PIC16(L)F72X Family Silicon Errata and Data Sheet Clarification

The PIC16(L)F72X family devices that you have received conform functionally to the current Device Data Sheet (DS41341E), except for the anomalies described in this document.

FIGURE 1: HFINTOSC FREQUENCY ACCURACY OVER DEVICE V_{DD} AND TEMPERATURE⁽¹⁾

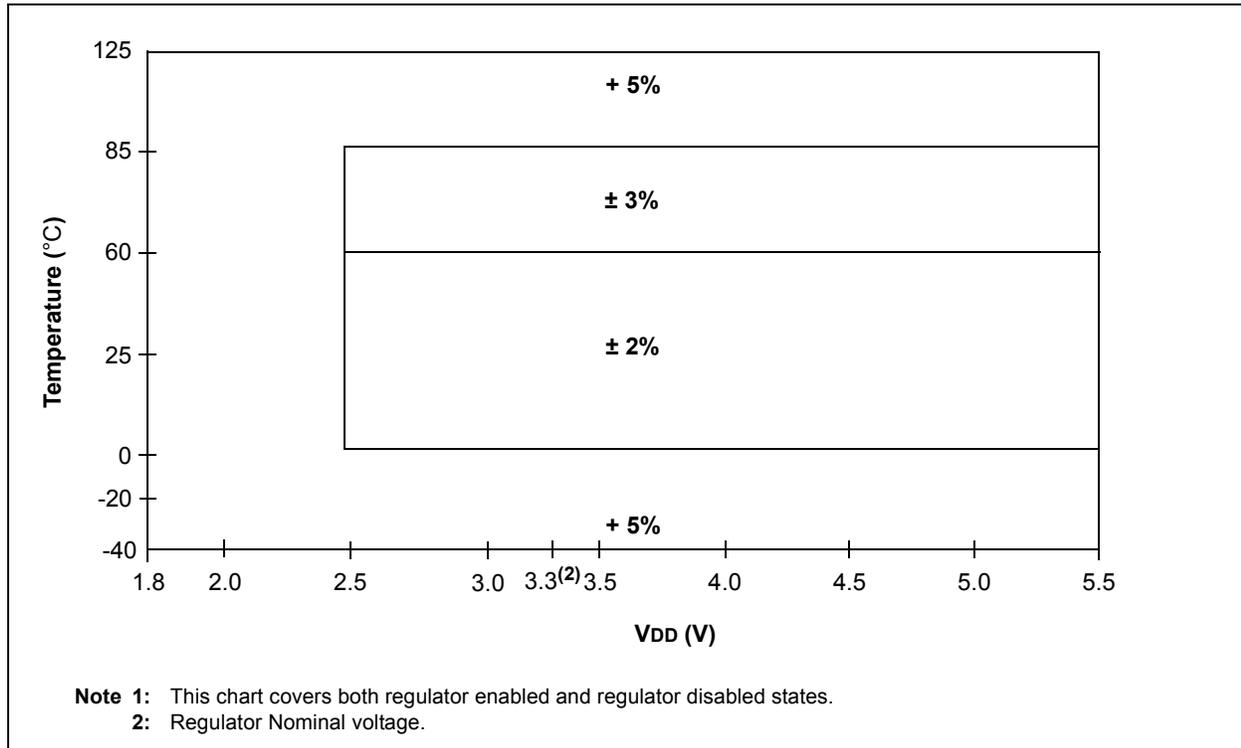
The frequency tolerance of the internal oscillator is $\pm 2\%$ from 0-60°C and $\pm 3\%$ from 60-85°C (see [Figure 1](#)).
